DOCKETS 50-266 AND 50-301
TECHNICAL SPECIFICATION CHANGE REQUEST 192
MODIFICATIONS TO TECHNICAL SPECIFICATIONS 15.3.3
"EMERGENCY CORE COOLING SYSTEM, AUXILIARY COOLING SYSTEMS,
AIR RECIRCULATION FAN COOLERS, AND CONTAINMENT SPRAY"
15.3.7 "AUXILIARY ELECTRICAL SYSTEMS" AND 15.5.2 "CONTAINMENT"
POINT BEACH NUCLEAR PLANT, UNITS 1 AND 2

TECHNICAL SPECIFICATION CHANGE REQUEST 192 DESCRIPTION OF PROPOSED CHANGES

ATTACHMENT 2
TECHNICAL SPECIFICATION CHANGE REQUEST 192
SAFETY EVALUATION

Figure 1

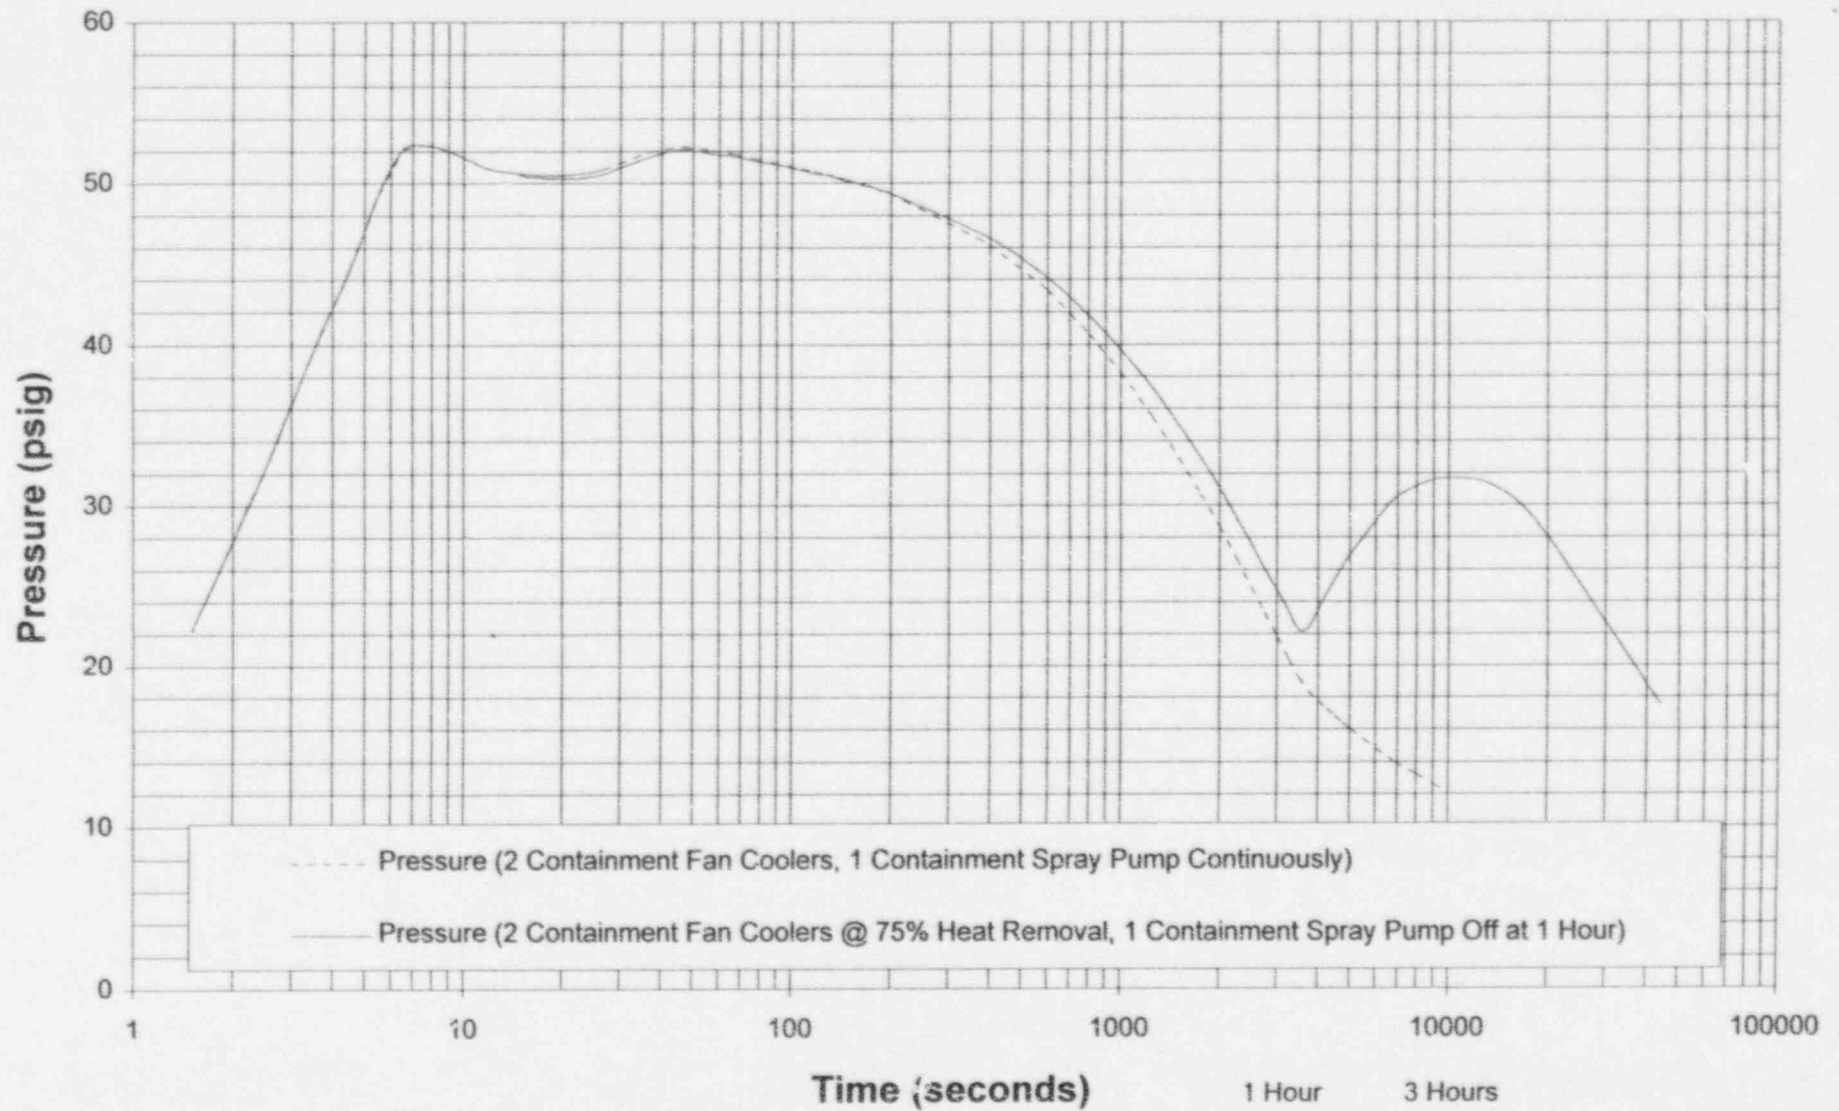
The results of the Westinghouse evaluation are shown graphically in the attached figures. Figure 1 is the containment pressure response and Figure 2 is the containment temperature response. Each figure compares the current FSAR case (two fan coolers and one spray pump operating throughout the event) to the reduced cooling case (spray termination at one hour; two fan coolers at 75% heat removal). The results show that the peak containment pressure is approximately 53 psig for both cases (well below the 60 psig containment design pressure), and the peak occurs prior to any heat removal by the fans and sprays for both cases. Therefore, peak containment pressure following a LOCA is unaffected by the reduced containment heat removal rate assumed in the evaluation.

Reducing the rate of containment heat removal by spray and fan coolers changes the shape of the containment pressure and temperature profiles. Figures 1 and 2 show that the overall impact of terminating spray at one hour and running two fan coolers with reduced heat removal is a more gradual depressurization to the one hour point, a small increase in pressure and temperature when sprays are secured at one hour, and a more gradual depressurization thereafter, compared to the original FSAR case with two fan coolers and one spray pump operating throughout the event.

The pressure profile in Figure 1 shows that containment pressure does not reach 60 psig, and will decay to less than 15 psig in the first 24 hours, which will limit the leakage to a rate at or below the assumptions of the dose analyses. The dose releases that would result from the revised pressure profile are therefore enveloped by the worst-case releases that have already been documented in the FSAR and found to be acceptable.

When the worst-case accumulator pressure decay profile is superimposed on the revised containment pressure profile in Figure 1, it can be seen that the T-ring seals will be supplied with air at a pressure above containment pressure throughout the analyzed duration of the transient. A positive seal pressure relative to containment pressure will maintain containment purge valve seal integrity. Therefore, the ability of the purge valve seals to support the containment isolation function will not be impaired by the revised containment pressure response shown in Figure 1.

- d. The capability to take a timely containment atmosphere sample after a LOCA is adversely affected by the revised containment pressure profile (Figure 1) for the reduced cooling case. However, a more realistic containment heat balance shows that cooling capability will exceed heat addition at one hour, and containment pressure will continue downward. This will allow a containment air sample to be taken within the time constraints imposed by NUREG-0737.
